**CITY OF AUSTIN**  
**Board of Adjustment/Sign Review Board**  
**Decision Sheet**

**CASE NUMBER:** C15-2014-0050

**ADDRESS:** 1190,1192,1194,1196,1198 NAVASOTA ST

**VARIANCE REQUESTED:** The applicant has requested a variance from Section 25-2-779 (G) of Small Lot Single- Family Residential Use standards to decrease the rear through lot setback from 15 feet to 10 feet on the Waller Street property line; and from Section 25-2-779 (I) to decrease one of the interior side yard setbacks on each lot from 3.5 feet to 1 foot in order to construct a single family home and AC unit in an "CS-MU-CO-NCCD-NP", Commercial Services - Mixed Use - Conditional Overlay - Neighborhood Conservation Combining - Neighborhood Plan (lots 1-3) and "CS-MU-CO-NP", Commercial Services - Mixed Use - Conditional Overlay - Neighborhood Plan (lots 4-5) zoning district. (Central East Austin)

C15-2014-0050

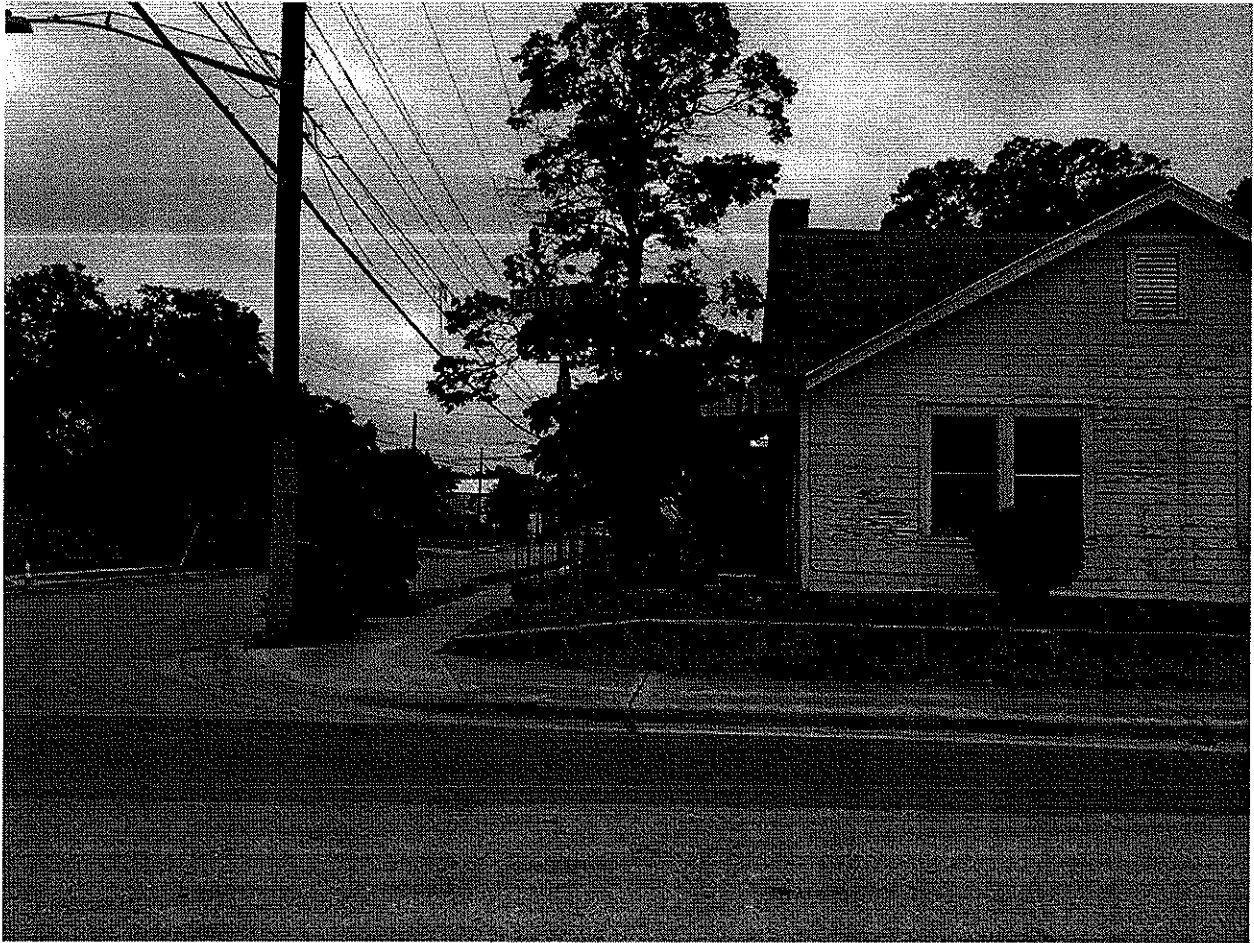
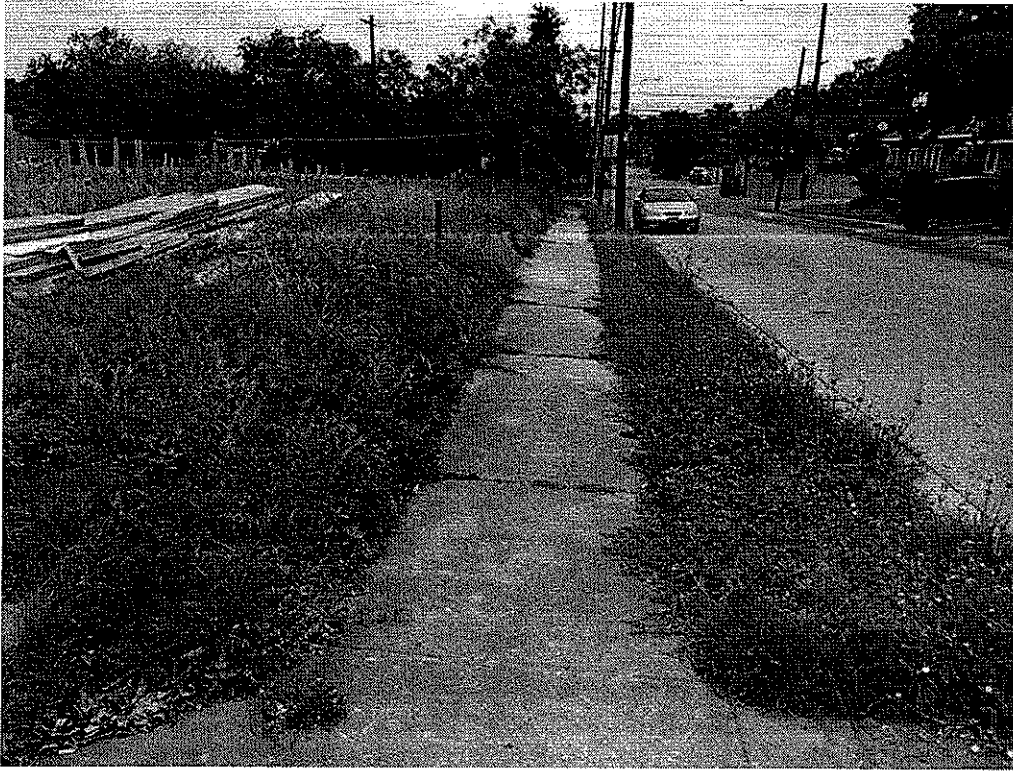
Approximately 20' from curb (10' building line?)

Forms set at 25' from curb (15' building line)

Intersection (Corner at 12th and Waller) see form location in relation to house at Catalpa/Navasota/Waller

- 3) Do you have any elevation sheets that we could add to the packet to show height, how the structures will look (not a requirement, but they may ask to see it and might save you a postponement). See attached the 3 different plans elevations

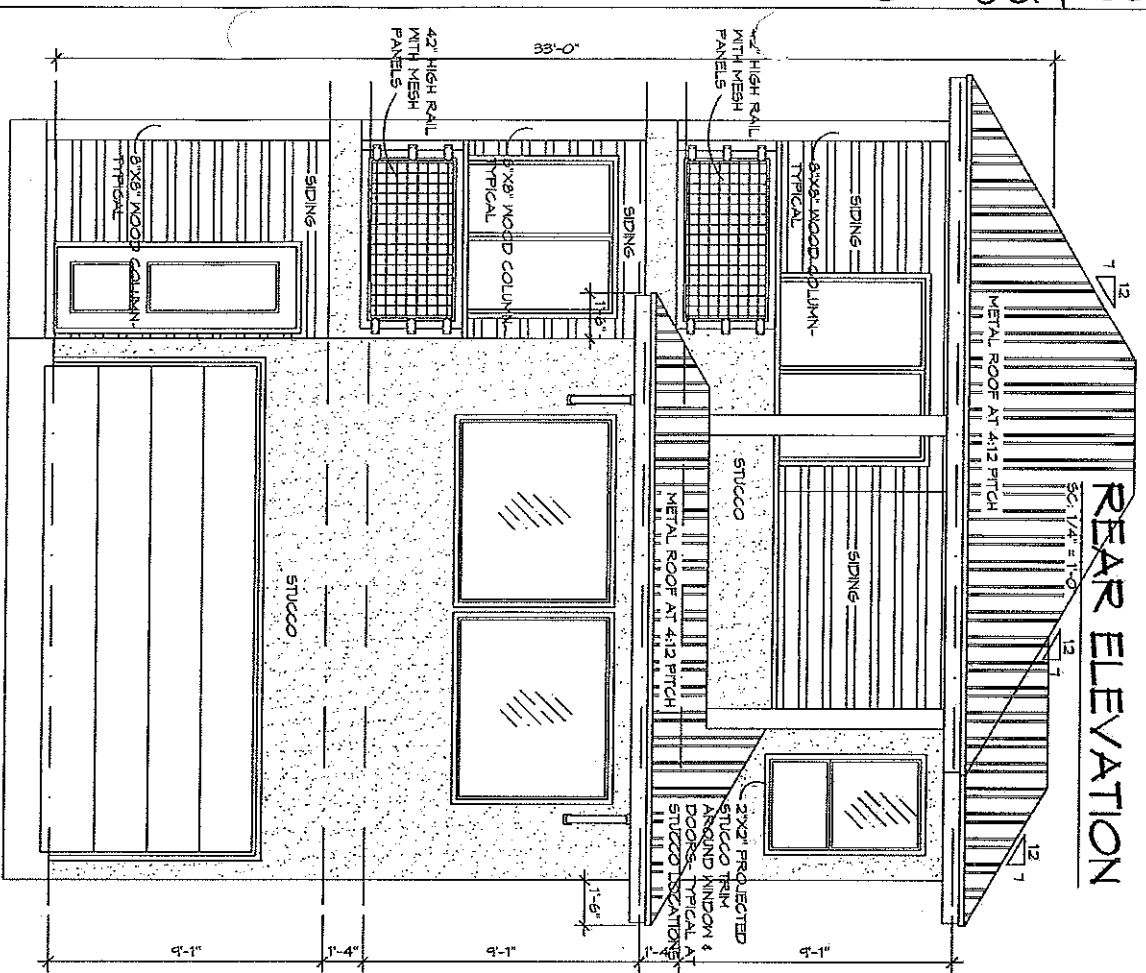
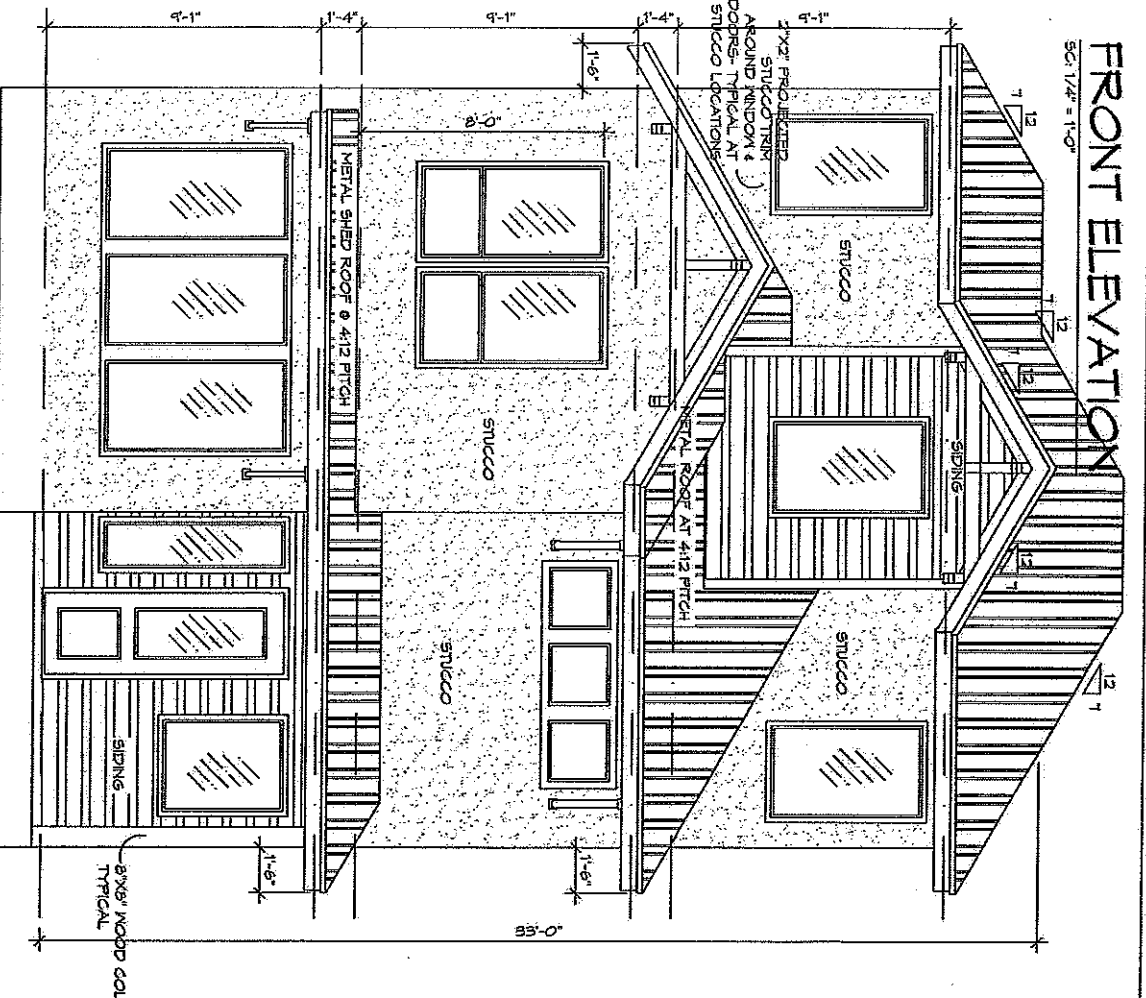
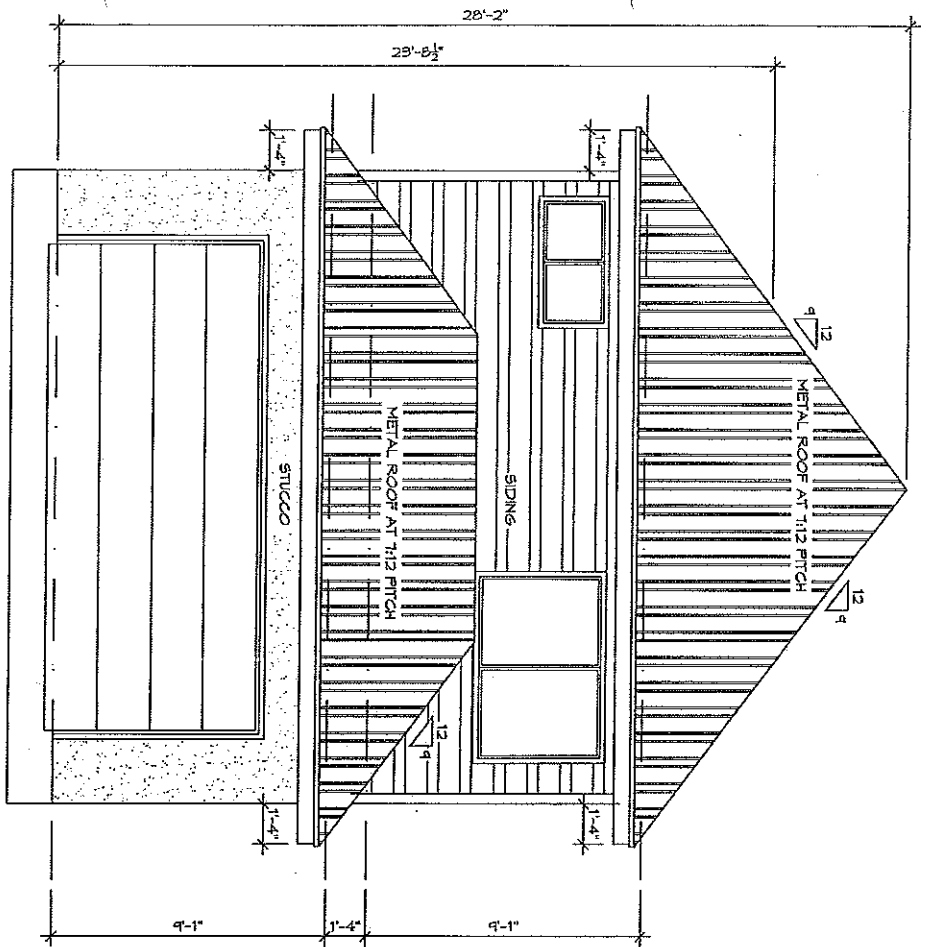
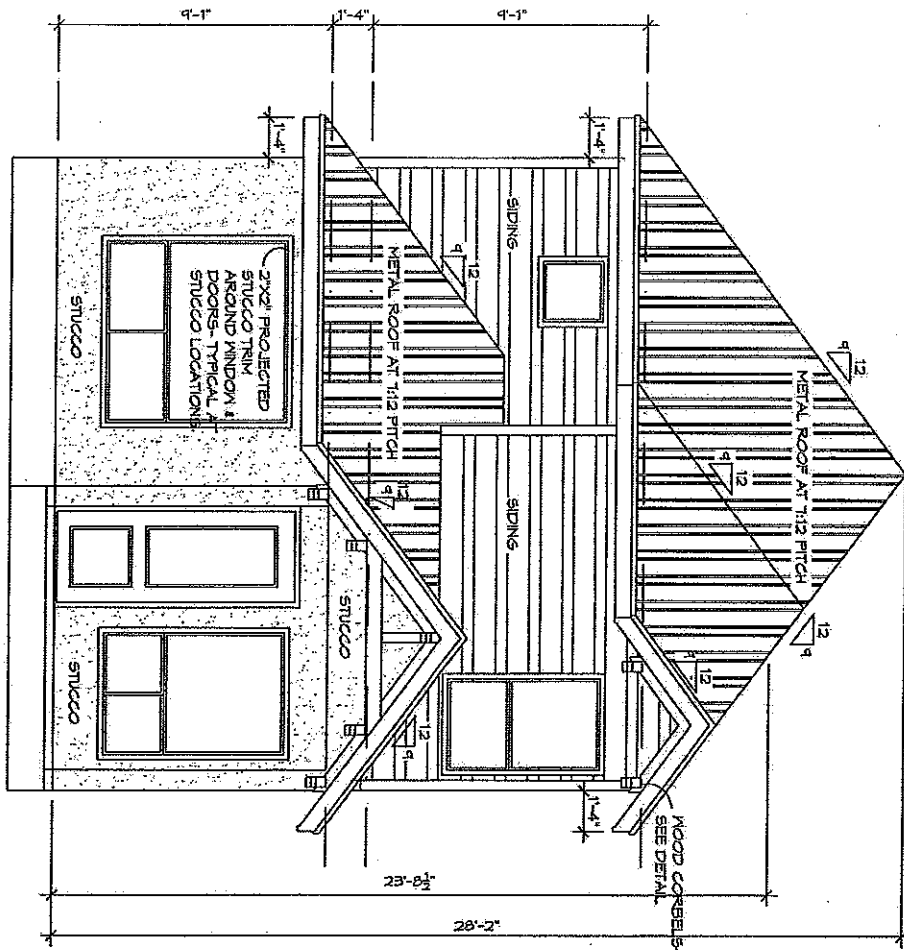
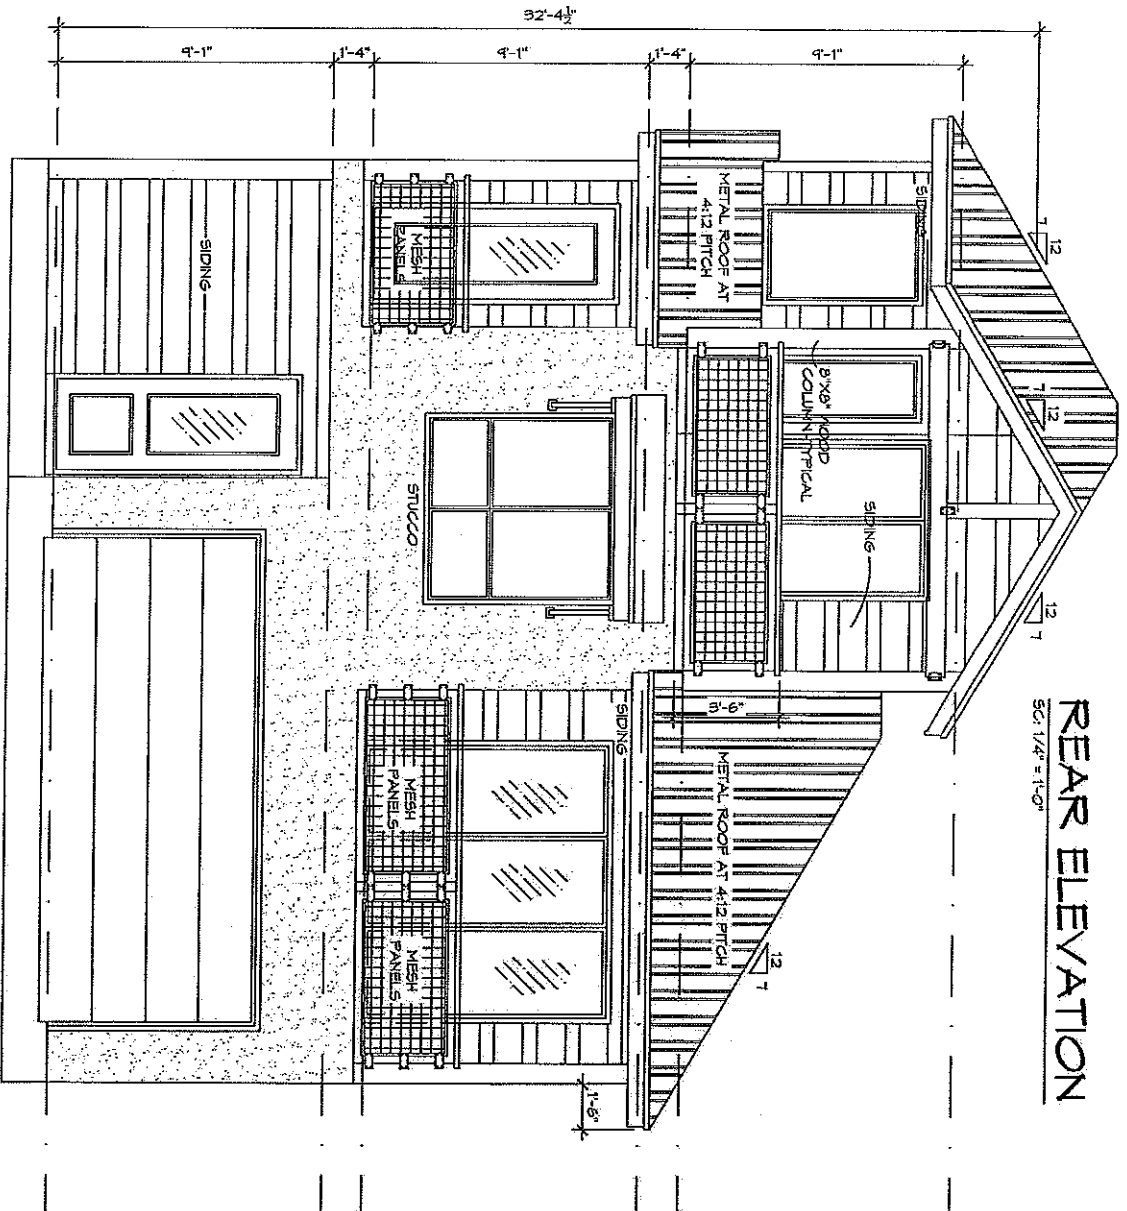
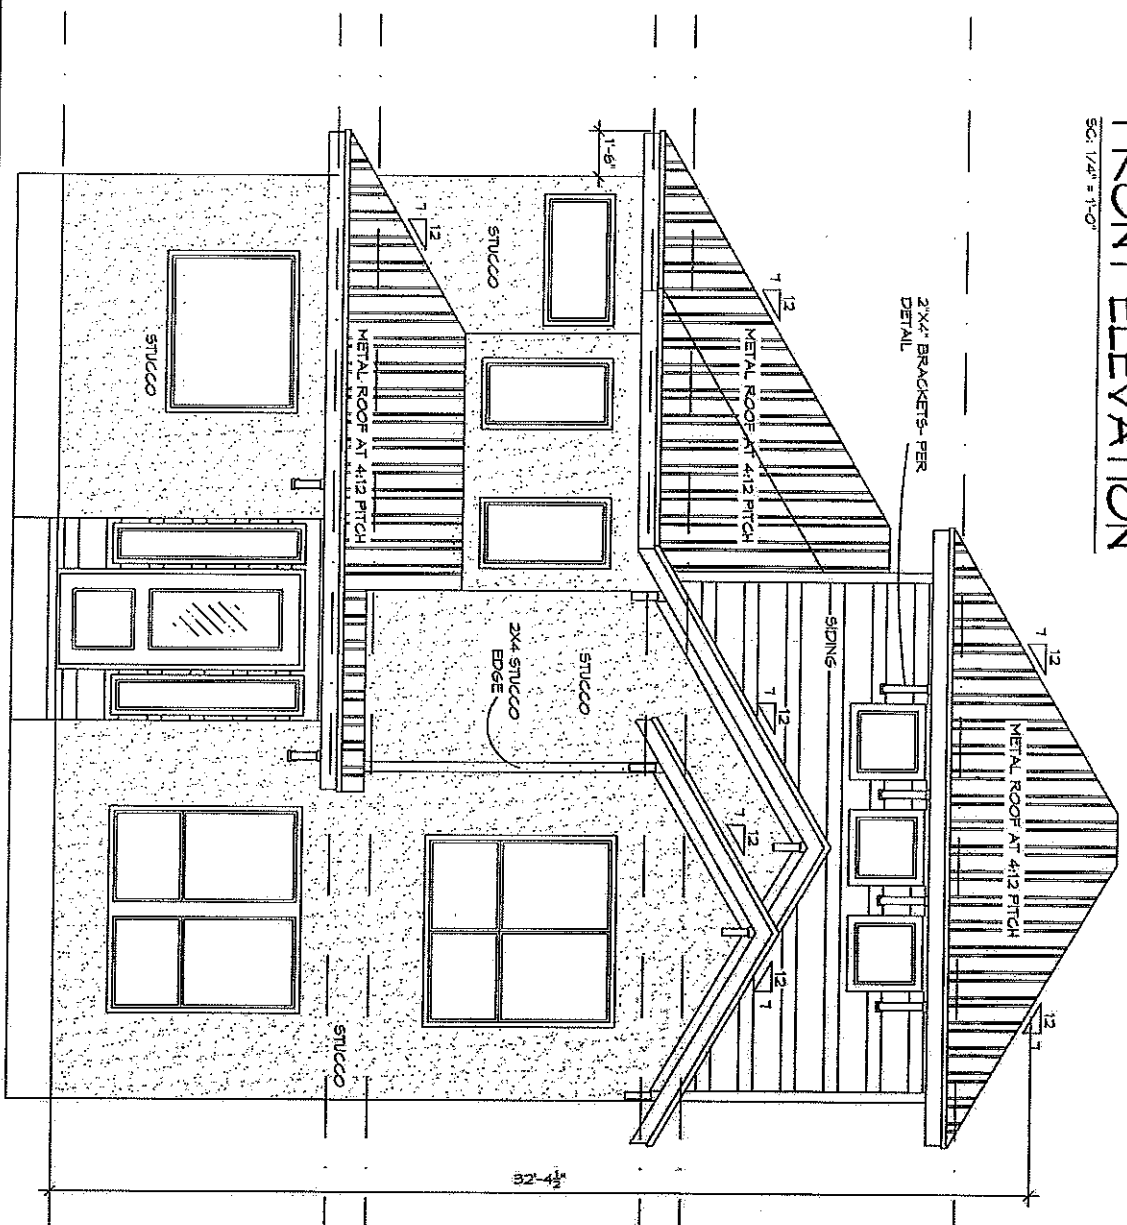
- 4) List of proposed building materials (see reason above, #3). These are listed on the elevations attached.
- 5) It might be more clear/clarify things if you provide a list by lot of which variances you're asking for, if you proceeded with the building plans shown. We will have to write the notice language/agenda up in this way (per lot), even though the findings can be made for all the lots combined (the way you've currently written attachment A. See below

Subdivision	Anderson Hill
Lot	5
Block	B
Address	1191 Waller St.
Plan Number	#4-1128
Date	11.21.13

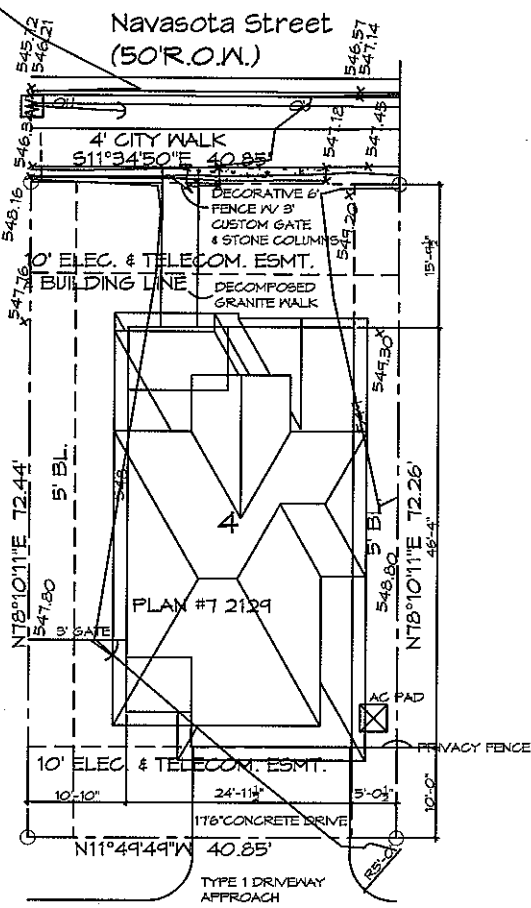
- ③ The plot plan submitted and proposed building footprint does not comply with the required setbacks for this property. The garage is encroaching into the front yard setback. Plans will have to be revised or the applicant must seek a Board of Adjustment Variance. 25-2-779

4. The property has multiple 10 foot easement (electric and telecom) lines along the property lines adjacent to the adjacent Right-of-Ways. The plot plan must be revised to correctly depict and label the existing 10 foot easements as platted and recorded with the Anderson Hill Subdivision.

5. No encroachments of structures (which includes eaves and roof overhangs) are allowed within the 10 feet (electric and telecom) easements on the subject property. Plans must be revised and approved by Austin Energy prior to Final Approval of this Plan Review.
